### PHOTOGRAPHS

#### BUILDING 26 SECTION E

**PHOTOGRAPH #9**

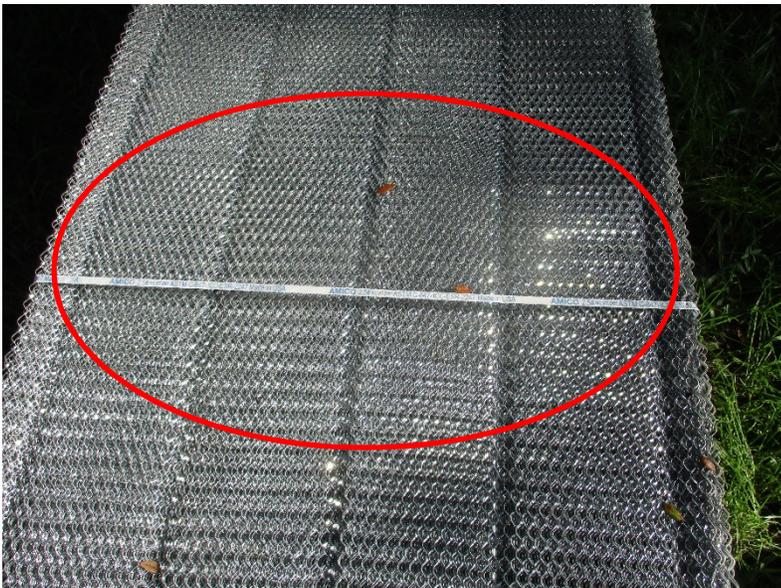
Stucco sub-contractor continuing to apply new lathing and stucco accessories.

**PHOTOGRAPH #13**

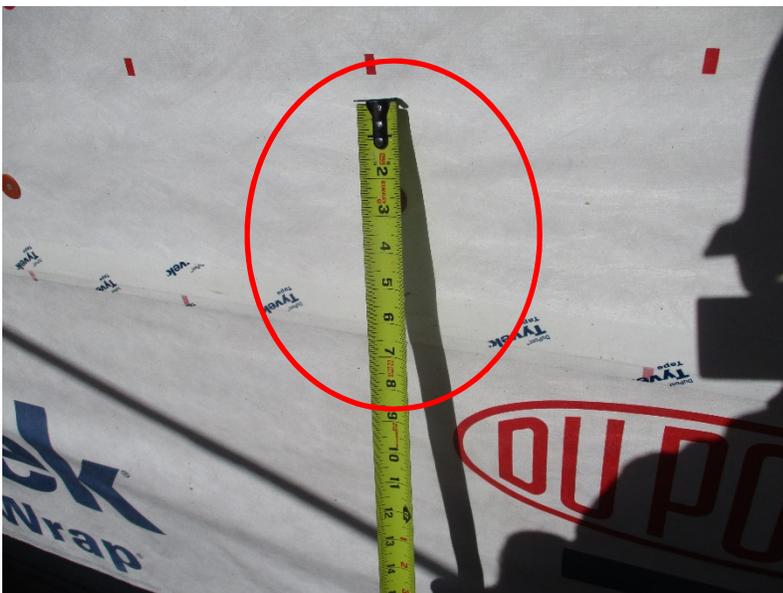
Pre-existing roof leaking and damaged roof sheathing is to be repaired by owners roofing contractors.
